## Stakeholder Comments Template

Submitted by	Company	Date Submitted
Simone Brant and Jaime Gannon simone.brant@cpuc.ca.gov	CPUC	June 2, 2017

Please use this template to provide your comments on the FRACMOO Phase 2 stakeholder initiative Revised Straw Proposal posted on May 1, 2017.

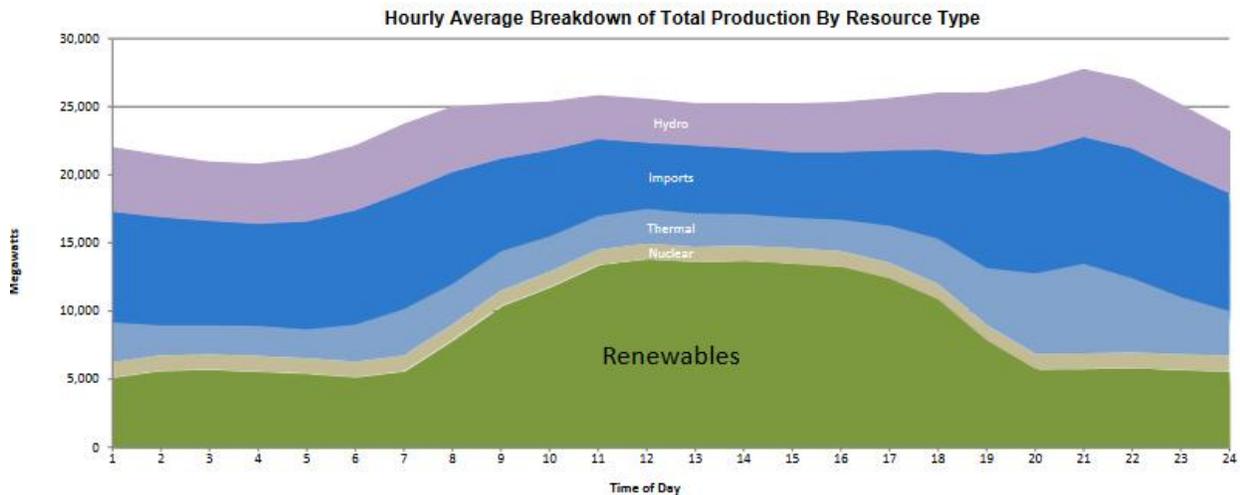
Restricting EFC eligibility to resources with start-up time and minimum run-times of less than 4.5 hours does not appear to address the need for resources that can meet ramping needs on a daily basis. By our estimation, overlaying these criteria on the current EFC list results in the following types of eligible resources (see table below). This list includes many resources that while technically able to respond quickly, have use limitations that make daily ramping infeasible.

Flexible capacity criteria should reflect actual system needs and the resources that can be regularly used to meet those needs. When we look at the typical resource mix (see graph below),<sup>1</sup> it appears that many types of resources, including fairly sizable quantities of imports, are helping to meet the net load ramp. This suggests that other strategies, such as the proposal made in this stakeholder initiative to allow flexible capacity from 15-minute intertie resources, should be considered. On the other hand, the fact that daily ramps are met with a large quantity of imports may indicate that energy market signals are incenting the resources needed to meet daily net load ramps.

Additionally, EFC criteria should be designed in a way that makes procurement feasible for LSEs and should not result in double procurement when considered in conjunction with local capacity requirements. The resources meeting the proposed 4.5 hour criteria skew to the north, and it appears that there may be inadequate resources in other areas.
